KITTERY POINT BRIDGE

PROJECT NO. BR-6458(00)X

ADDENDUM 10 A

REVISED ABUTMENT ELEVATIONS

KITTERY POINT BRIDGE
OVER
SPRUCE CREEK
IN THE TOWN OF
KITTERY
YORK COUNTY
ABUTMENT DETAILS

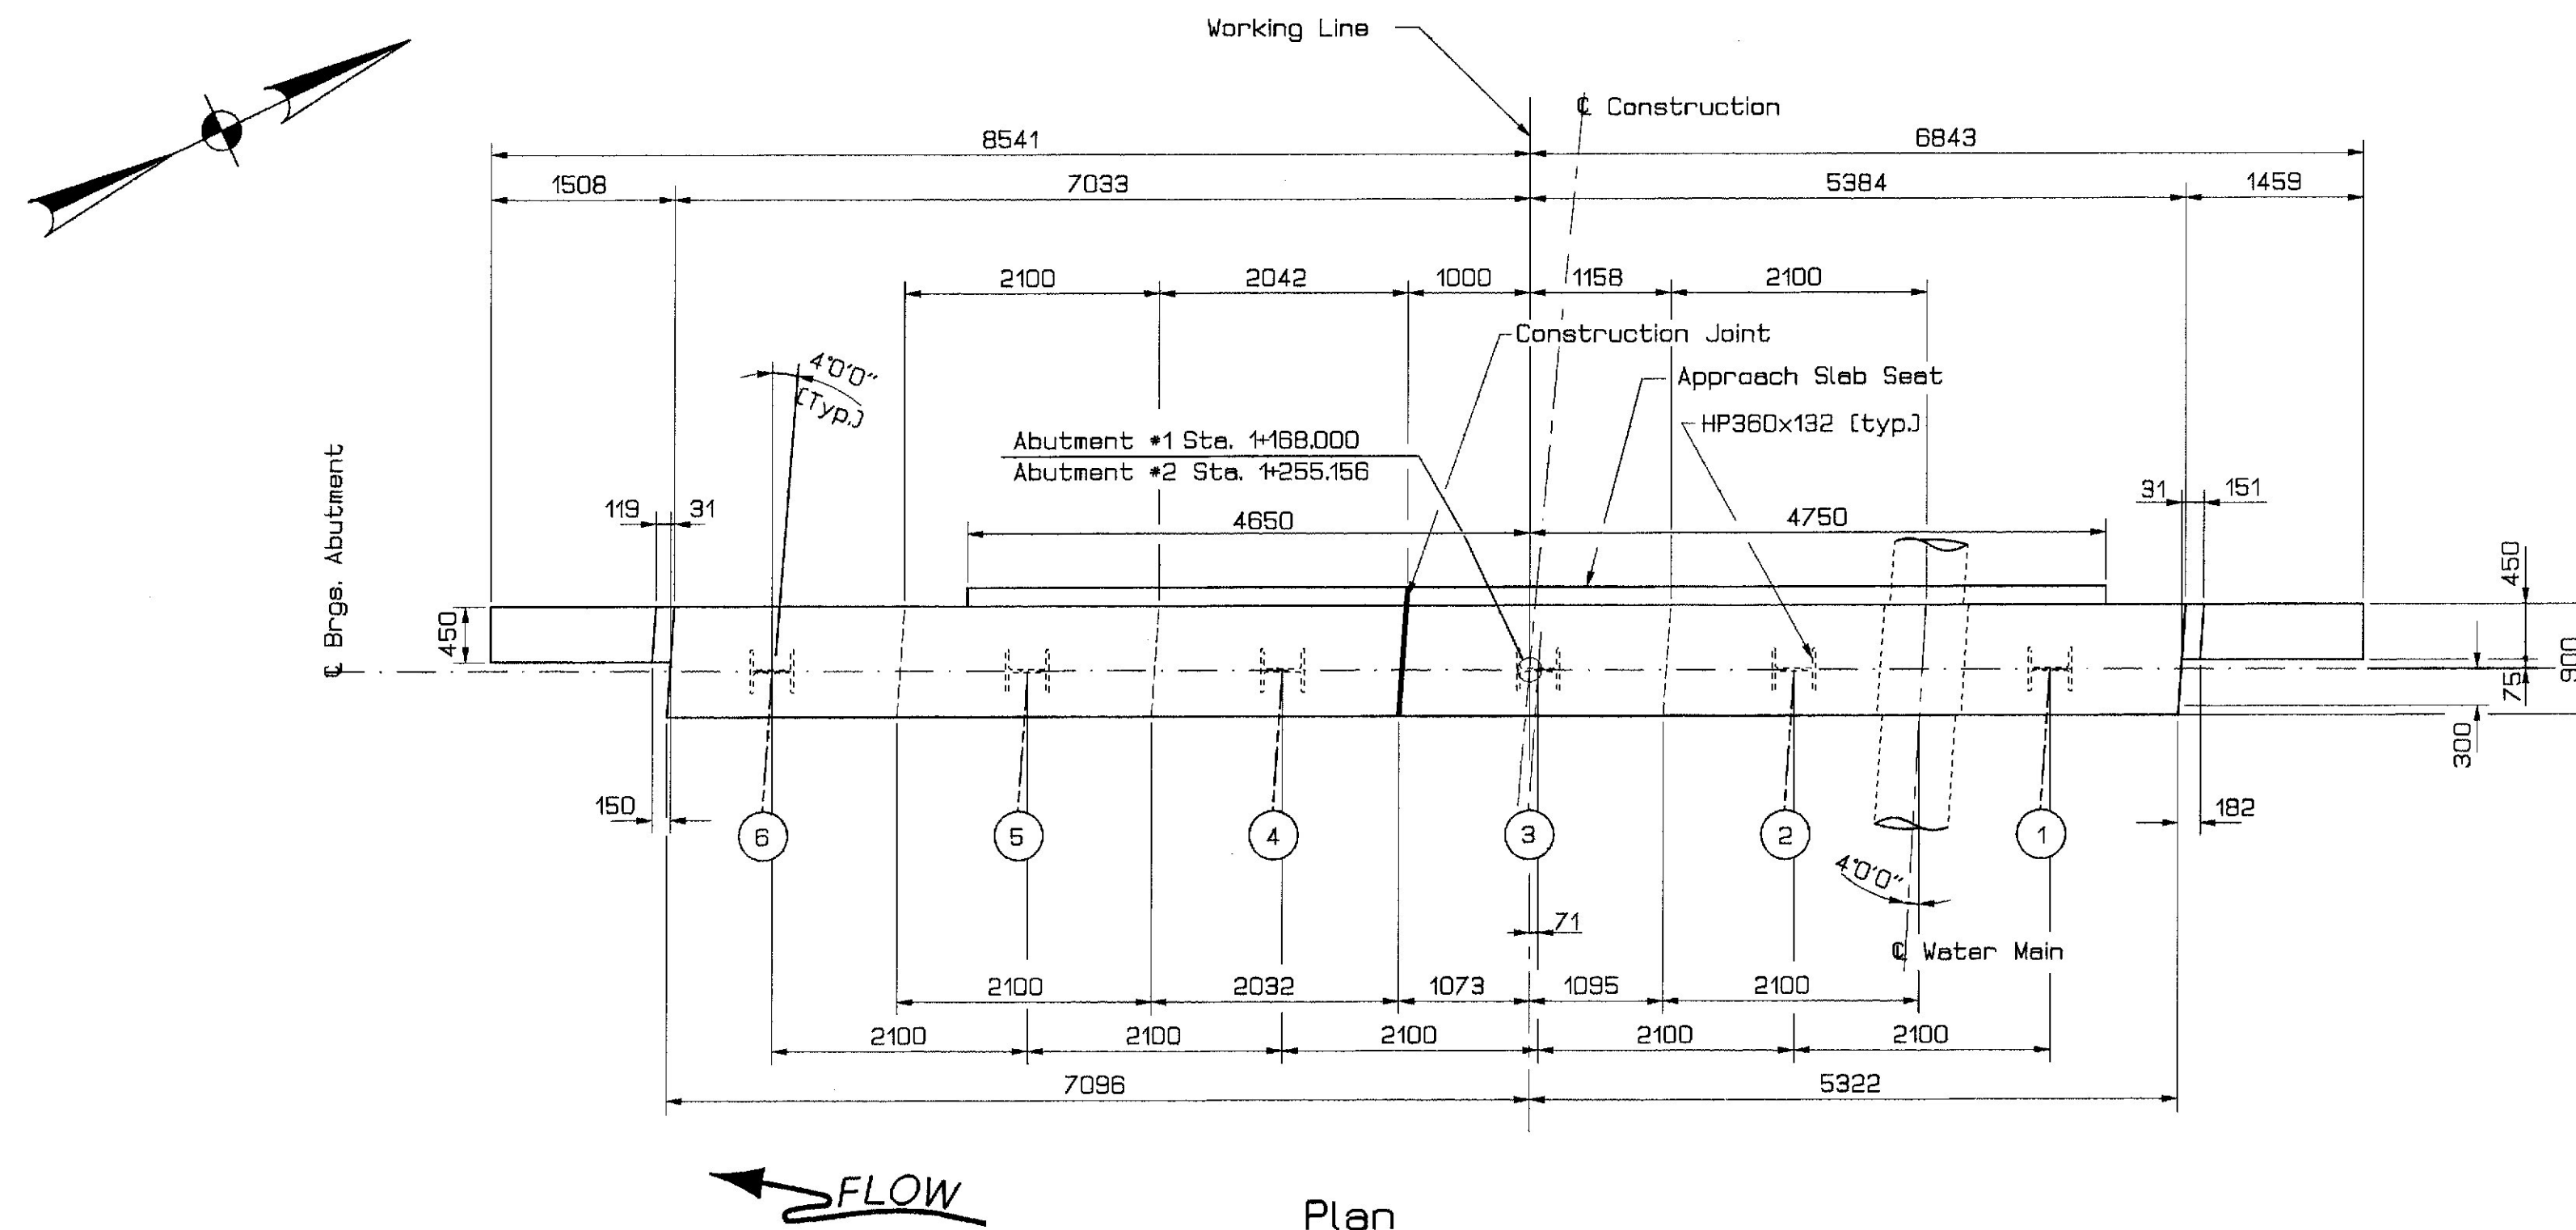
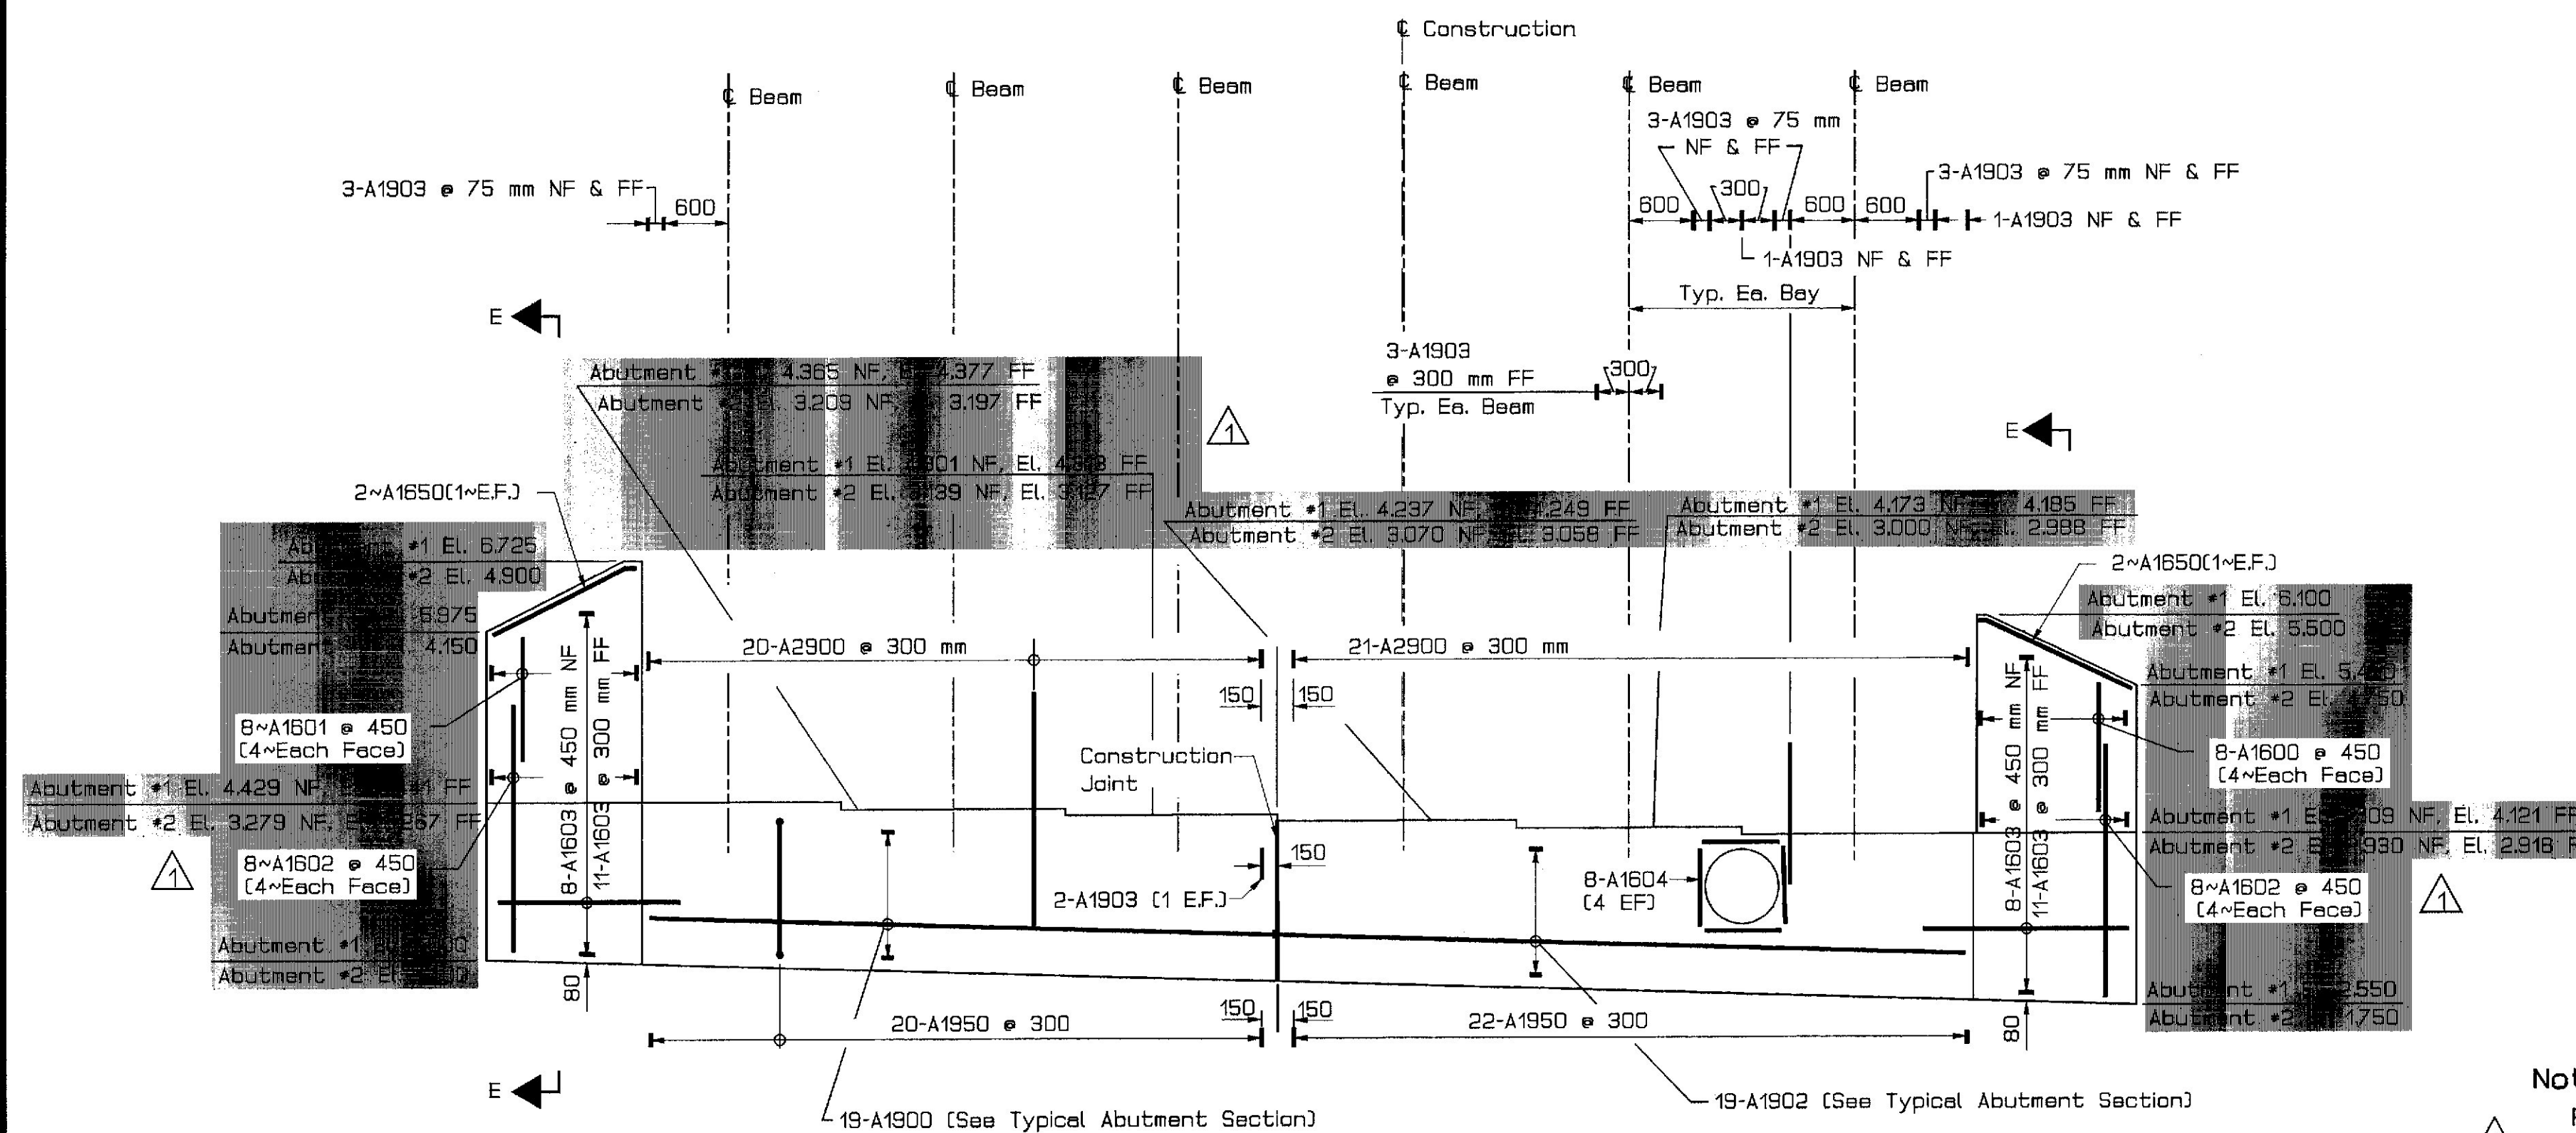
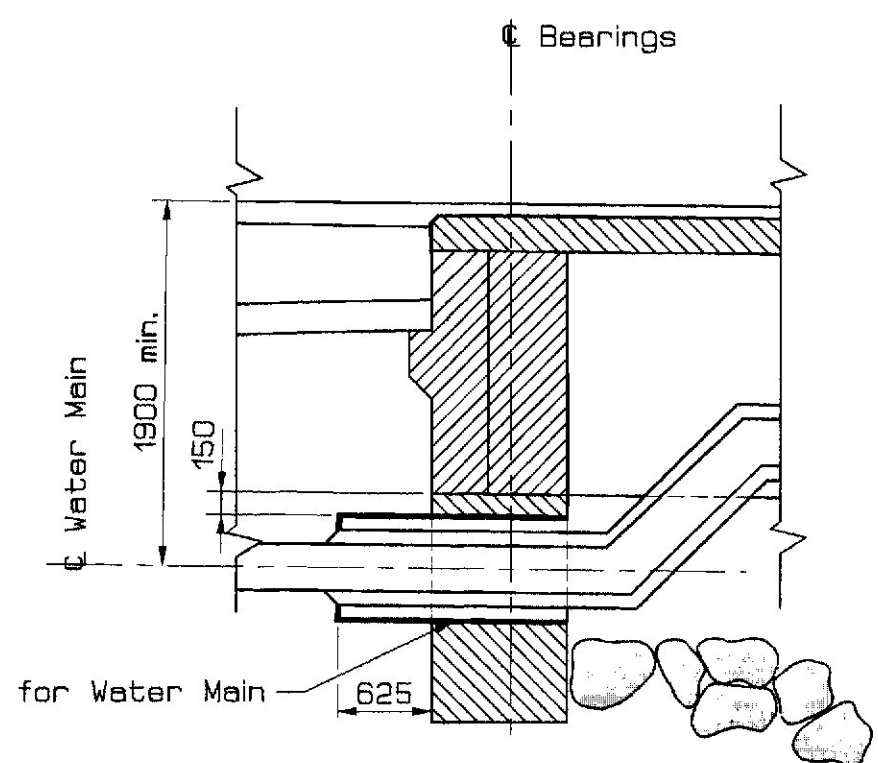
Note:
For All Elevations Shown Inside
The Shaded Area See
Revised Abutment Elevations

REVISION	DESCRIPTION	DATE
1	Elevations	5/1/98
